**In The Drawings**

**REMARKS**

## ANNOTATED SHEET SHOWING CHANGES

8/10

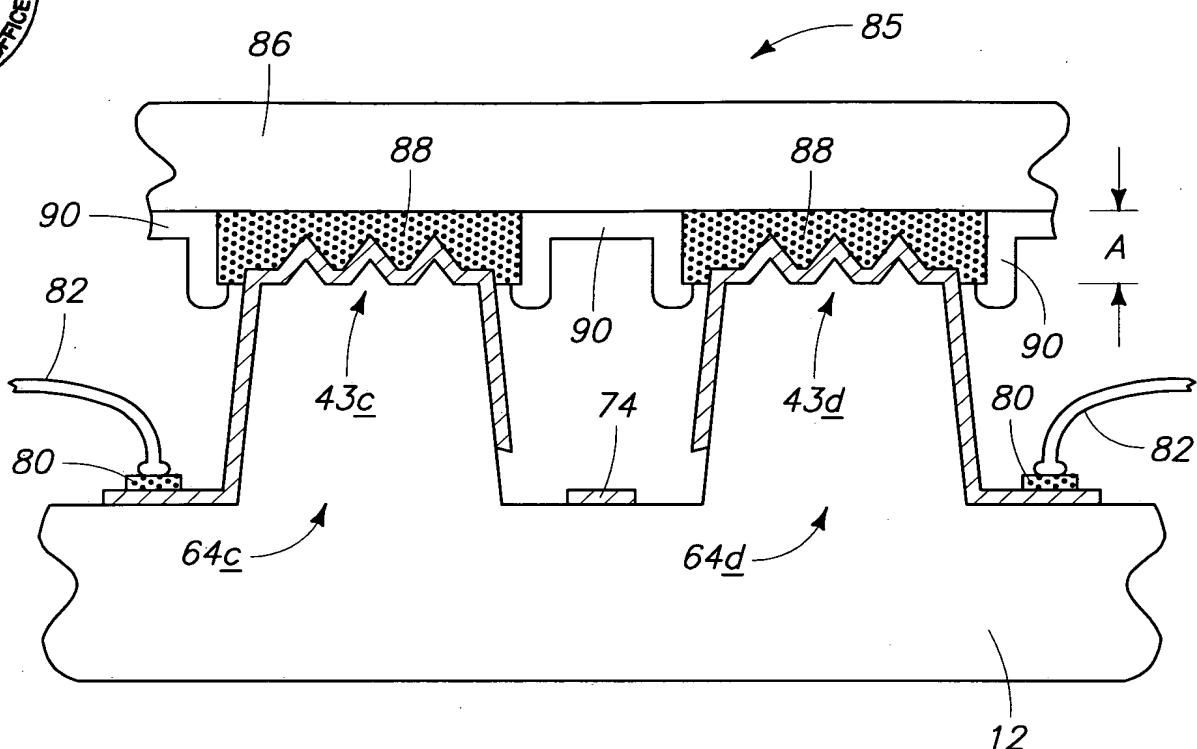
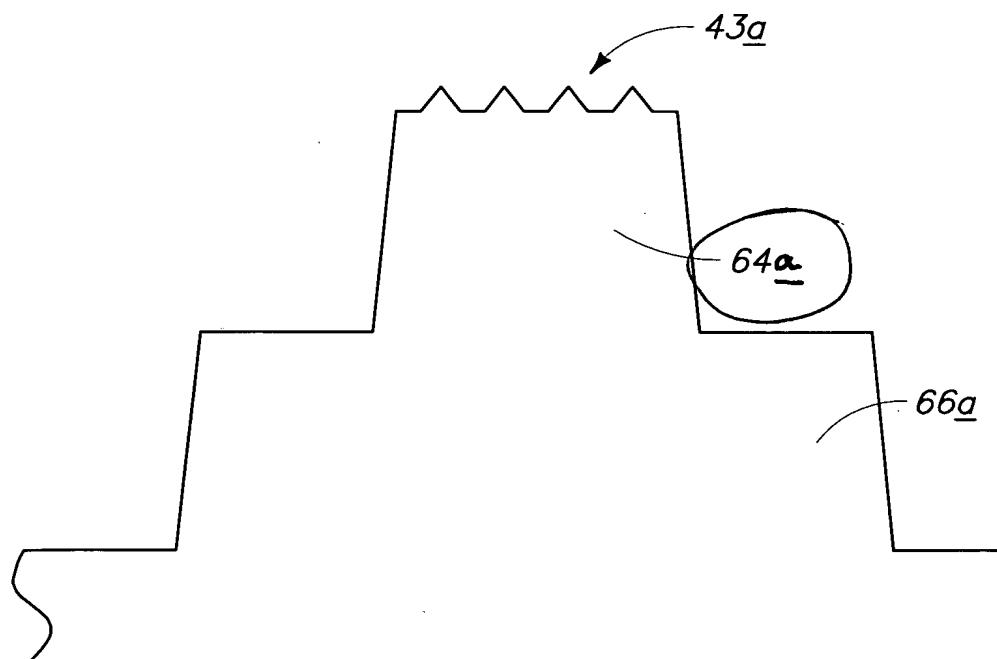
Please amend Fig. 15 of sheet 8 as shown on the enclosed marked-up-in-red copy thereof. A revised formal drawing is enclosed under separate cover addressed to the Chief Draftsman. Acknowledgment of receipt of the formal drawing sheet and its acceptance into the file is requested.

Fig. 15 of the drawings is amended to correct an inadvertent error. Support for the amendment is provided by the originally-filed application at page 14, line 17.
